Service Manual

SUZUKI Automobile Genuine
AM/FM 6-Disc CD Changer Deck

Model PS-2533B-C,D
(Genuine No.39101-55GF1-000)

Difference from original models is beep sound function.

CD Changer mechanism section : Main module
(Reffer to page7,8,9 of original model's manual.)

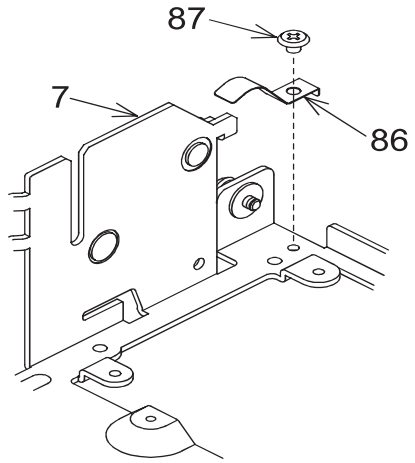
Original models also use below updated parts.

NO.	PART NO.	DESCRIPTION	Q'TY
7	966-0597-24	CHASSIS ASSY	1
85	347-6974-21	FPC COVER	1

Original models also use below added parts.

NO.	PART NO.	DESCRIPTION	Q'TY
86	620-1604-20	DR-PLATE-SPRING	1
87	716-1850-01	SCREW(M2 x 2)	1
